Staff Report & Recommendation

SUBJECT: PB20-0390, a.k.a. PB17-0171. 1052 Ocean Drive - Palace Bar & Restaurant.

Per applicant's performance plan (Page A 1.02). the hatched area is where the outdoor entertainment/performance is proposed.

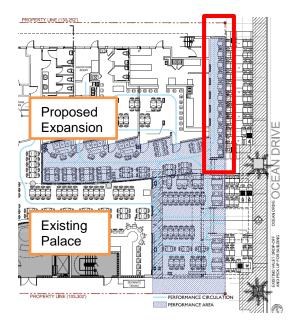
To minimize the impact on Ocean Drive with the additional outdoor entertainment and the potential impact on pedestrian flow on the sidewalk, staff is recommending limiting the area for the outdoor entertainment that is proposed on the ground floor to the neighboring building on the north side, see tables bellow and images below.

To prevent any potential impact on pedestrian safety and flow on the sidewalk, staff recommends that the small terrace with tables facing Ocean Drive be prohibited from outdoor entertainment and performance uses.
